# ACCESSIBILITY ASSESSMENT

167588.24R000-005.303

## **ADA TITLE II ASSESSMENT**

Anderson Stadium  
910 Raleigh Road  
Chapel Hill, North Carolina 27514

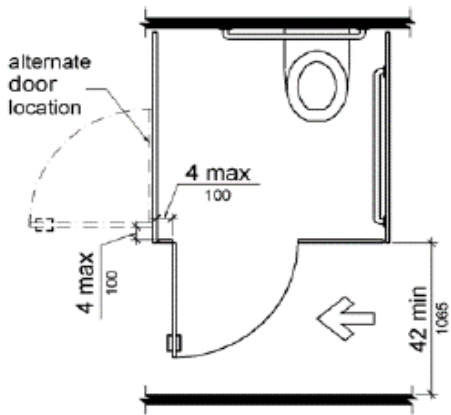
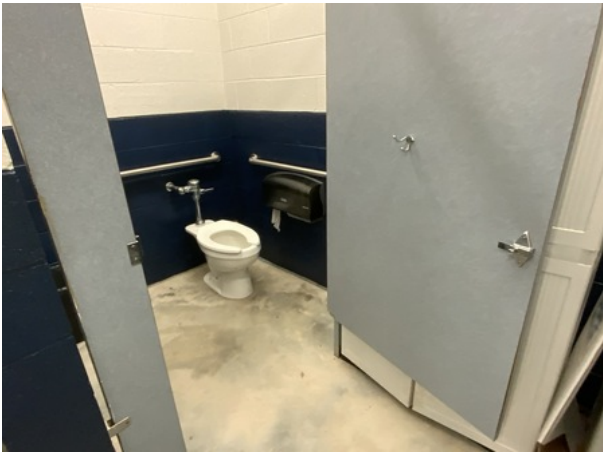
Assembly	Restroom
Type	Restroom/Bathroom - Toilet Stall
ADA Standard	309, 404.2.7, 604.8.1.2
Barrier Detail	The wheelchair stall door is not compliant.
Location Description	Women's Restroom
Observed	May 16, 2024 by javondrick.orange@bureauveritas.com

The wheelchair stall door is not self closing and a door pull is not provided on the interior side.

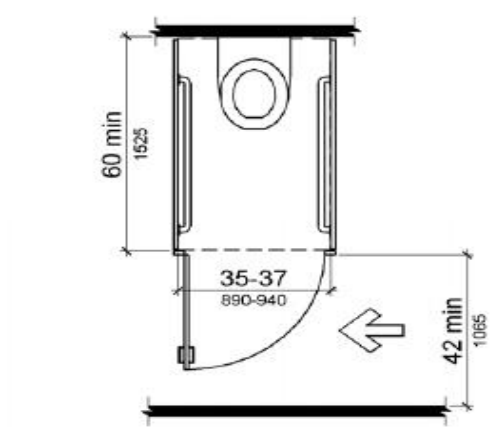
Assembly	Restroom	
Type	Restroom/Bathroom - Toilet Stall	
ADA Standard	213.3.1, 309, 404.2.7, 604.8.2	
Barrier Detail		
The ambulatory stall size is not compliant, or an ambulatory stall is not provided.		
Location Description	Women's Restroom	
Observed	May 16, 2024 by javondrick.orange@bureauveritas.com	
Site Conditions	The ambulatory stall is 41" wide.	
Resolution		
Provide a compliant ambulatory stall, where six or more toilet compartments are provided or where the combination of urinals and water closets totals six or more fixtures. An ambulatory stall is minimum 60" deep and the width is minimum 35" and maximum 37". Grab bars shall be provided on both sides of the compartment. The side grab bars shall be 33" minimum to 36" maximum above finish floor to the top of the gripping surface, except in children's (ages 3-12) water closets where horizontal grab bars shall be 18" minimum and 27" maximum above the finish floor to the top of the gripping surface. Horizontal grab bars should be installed at a consistent height. The side wall grab bars shall be 42" long minimum, located 12" maximum from the rear wall and extending 54" minimum from the rear wall. The centerline of the toilet shall be minimum 17" to maximum 19" from the side wall. Toilet compartment doors for ambulatory stalls shall be minimum 32" wide when open 90 degrees and have minimum 80" high clearance. If the approach is to the latch side of the compartment door, clearance between the exterior side of the door of the compartment and any obstruction shall be 42" minimum. The door shall be self-closing. A compliant door pull shall be placed on both sides of the door near the latch. Toilet compartment doors shall not swing into the minimum required compartment area. [ADVISORY: It is advisable, but not required, to use the specifications for children where children are the primary users of the restroom. Guidance in applying the specifications for children according to the age group served reflects the differences in the size, stature, and reach ranges of children ages 3 to 12. The specifications chosen should correspond to the age of the primary user group. The specifications of one age group should be applied consistently in the installation of a water closet and related elements. Water Closet Centerline: Ages 3 and 4- 12"; Ages 5 through 8- 12" to 15"; Ages 9 through 12- 15" to 18". Toilet Seat Height: Ages 3 and 4- 11" to 12"; Ages 5 through 8- 12" to 15"; Ages 9 through 12- 15" to 17". Grab Bar Height: Ages 3 and 4- 18" to 20"; Ages 5 through 8- 20" to 25"; Ages 9 through 12- 25" to 27"; Dispenser Height: Ages 3 and 4- 14"; Ages 5 through 8- 14" to 17"; Ages 9 through 12- 17" to 19".]
